**To: BZA**

**Date: 3 March 2016**

**Subject: BZA Case 19101 (Darryl) O.A. Sulekoiki 2112-2126 3<sup>rd</sup> St NE**

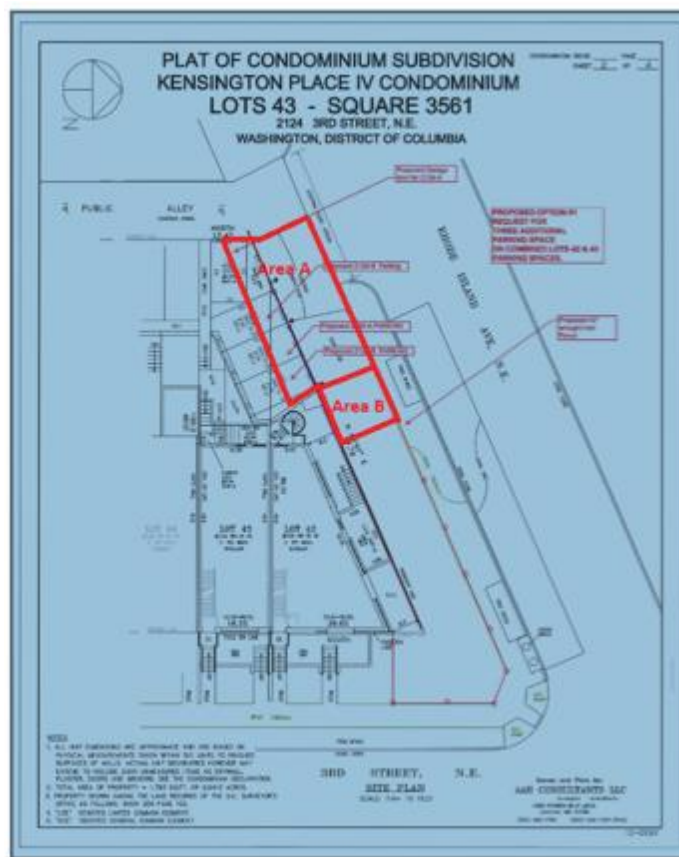
- “Driveway shall not be located within sixteen feet (16') of another driveway or alley” DCMR 24-1110.2(e). The proposed driveway and existing curb cut abuts the alley entrance.
- “Driveways shall be designed to avoid vehicle backing and vehicle waiting within the street” DCMR 24-1110.2(g). The proposed configurations require vehicle backing into the busy street.

- “Where feasible, access to loading and parking facilities shall be from an alley” DCMR 24-1110.1(b). The adjacent alley provides adequate access to parking in configurations not mentioned by applicant.
- Parking on public space on gateway streets is generally not permitted (Parking in Public Space application FAQ [http://ddot.dc.gov/sites/default/files/dc/sites/ddot/publication/attachments/pub\\_parking.pdf](http://ddot.dc.gov/sites/default/files/dc/sites/ddot/publication/attachments/pub_parking.pdf). Accessed 3/2/16). Rhode Island Avenue, or U.S. Route 1, is a gateway street.

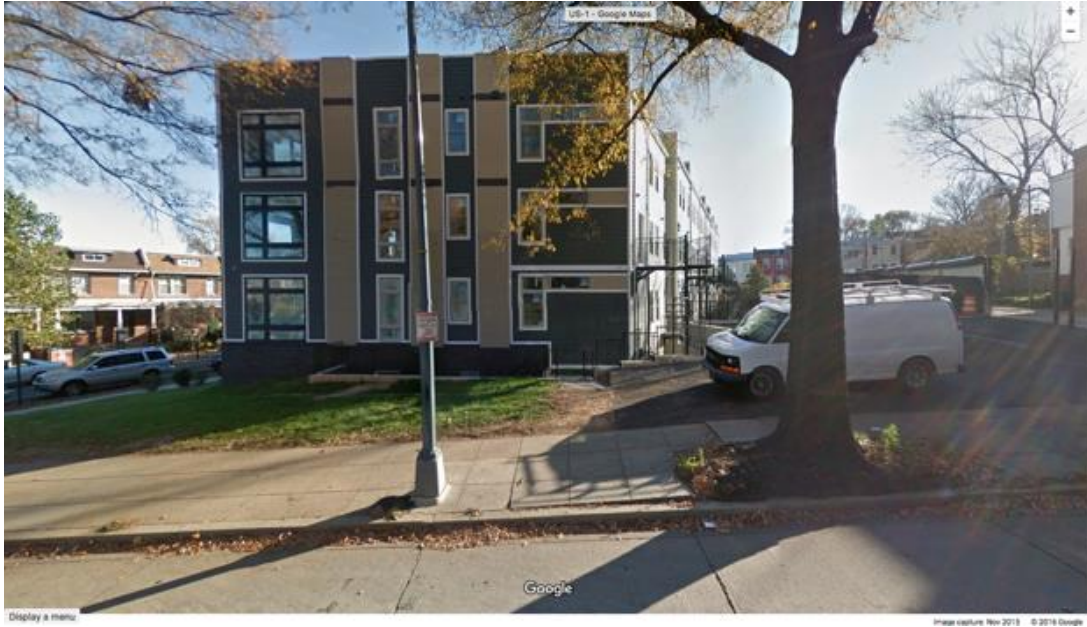
Finally, I note that the asphalt installed in public space at present does not follow either the initial approved drawings, nor the drawings in the applicant's exhibits. The asphalted area in actuality (below, outlined as Area A + Area B on plan image; also Google street view image) is larger than the plan proposed (Area A only).

In addition, there are newly installed two utility boxes and two security bollards (see Google image below) in the public space adjacent to Lot 24 which do not appear to be approved. I surmise this may be a reason why the applicant has not included current photos of the site in his application and exhibits.
